How Colonial Durham's 2020 [Site Plan](#) *fails to meet*

Town of Durham **[ARCHITECTURAL DESIGN STANDARDS](#)**

Joshua Meyrowitz, 7 Chesley Drive, Durham, NH
(Mill Plaza Abutter & "Party in Interest" per [NH Municipal Org](#) definitions)

Enhanced version of "Public Comment" at the July 22, 2020, Planning Board meeting.
Underlined color text indicates a hot link.

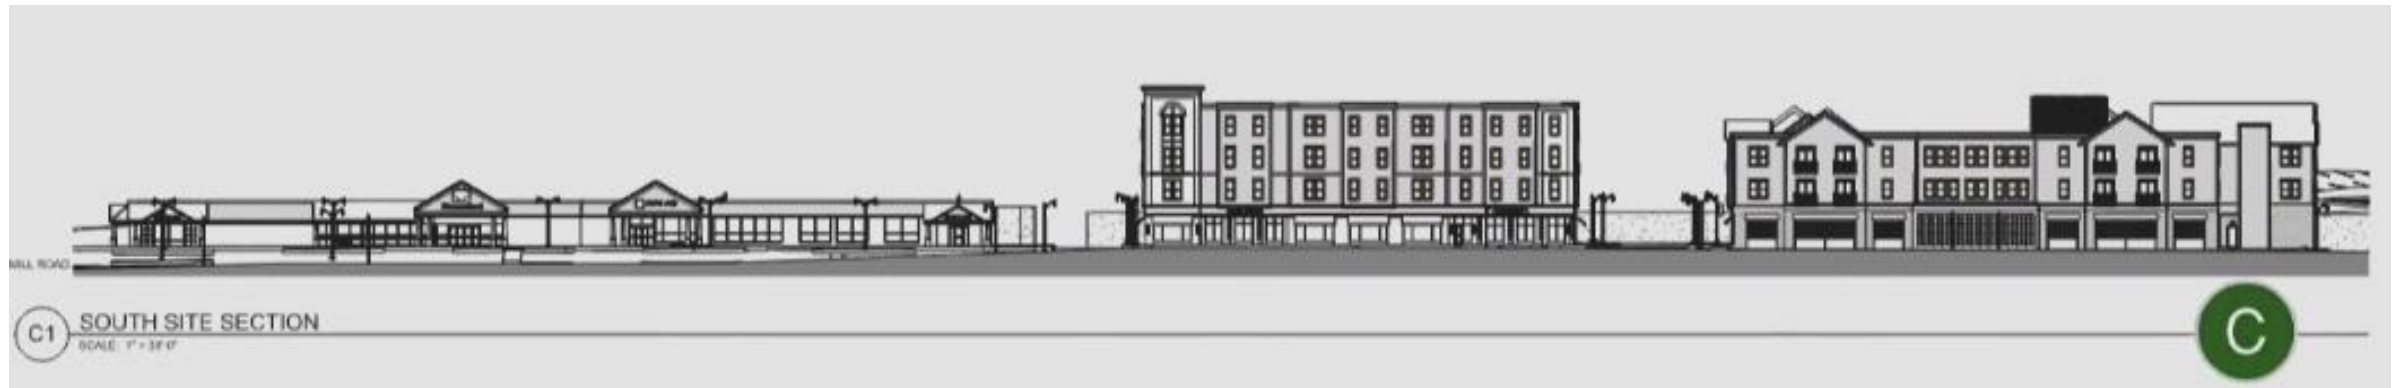
Even an amateur can see mismatches between CDA renderings and spirit and intent of the architectural standards **“to produce beautiful structures, respectful of place, context, and tradition....”**

Instead, the proposed buildings are very boring, blockish, massive, synthetic, tacky-looking, “dropped in from Mars,” and disrespectful of place, of social and natural context, and of Durham tradition.

Incoherent style mixes; oversized for site; inauthentic “faux balconies”

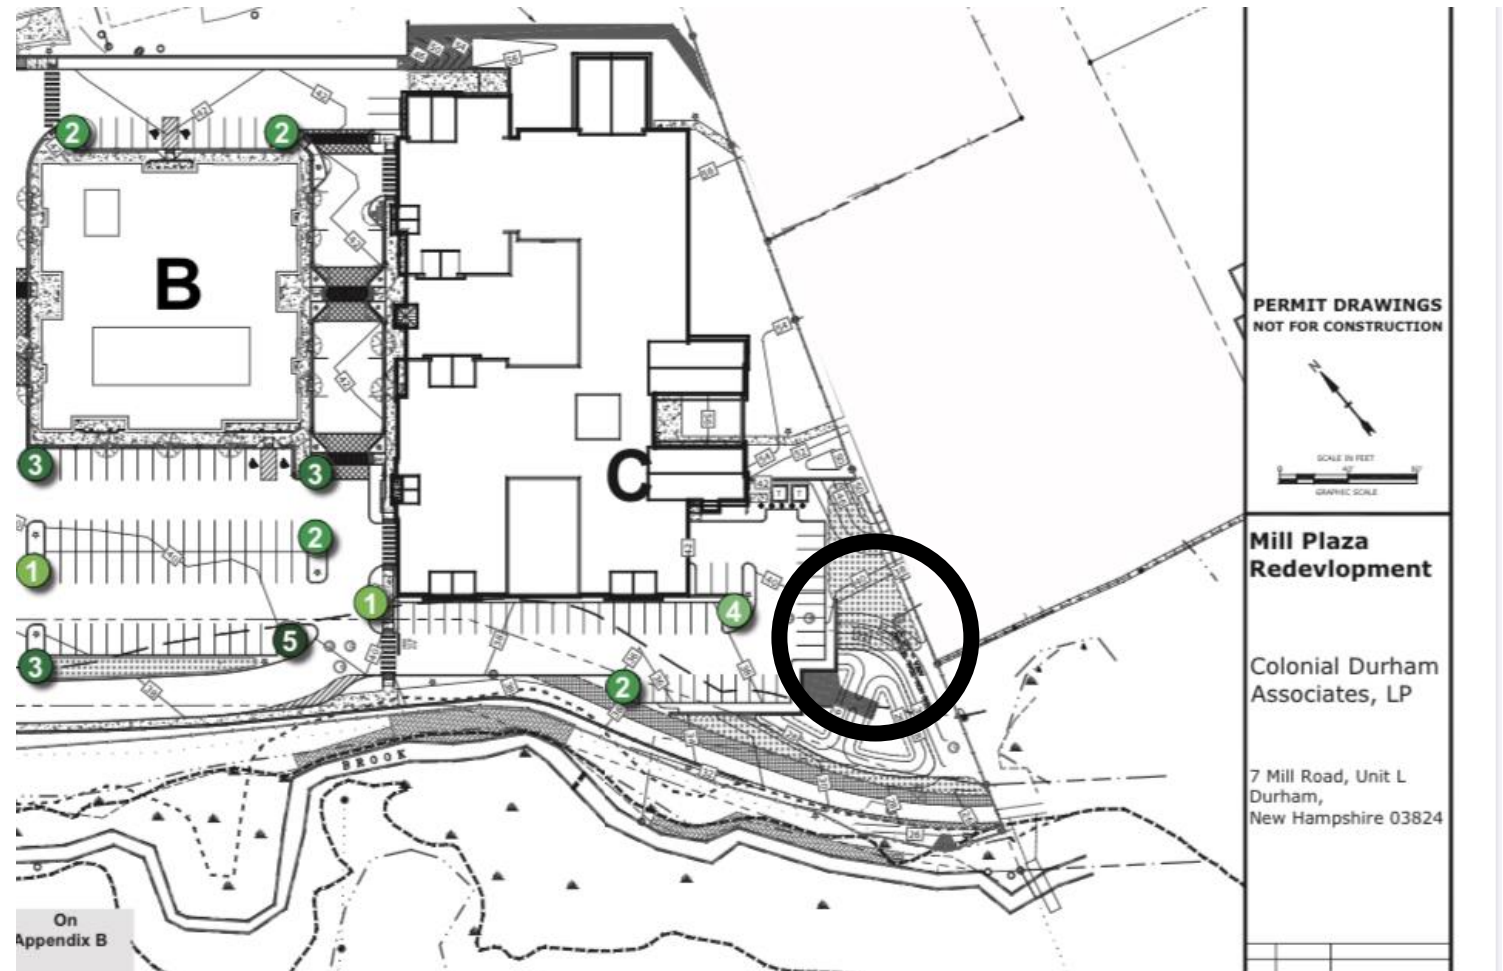
Perhaps embarrassed with [public mentions & pictures](#) of long-dead (for decades!) trees, CDA uprooted and clustered them at rear of the lot at start of July 2020.

But beauty and public safety do not seem to be CDA's prime goals, as is evident from deep and dangerous empty pits that were there for four weeks.*

*The Plaza manager and staff planted new trees in the emptied pits on July 31 2020.
